Errata: CS5396 Revision B

CS5396/CS5397 : 120 dB, 96 kHz Audio A/D Converter (DS229PP2 SEP '97)

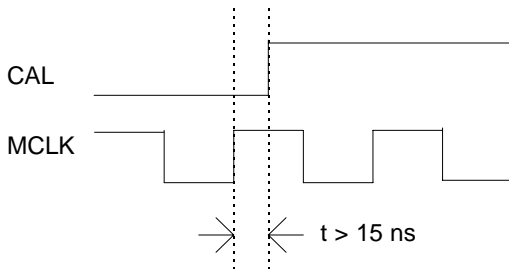
- When in slave mode, the part must be calibrated with the LRCK low as in the following diagram:
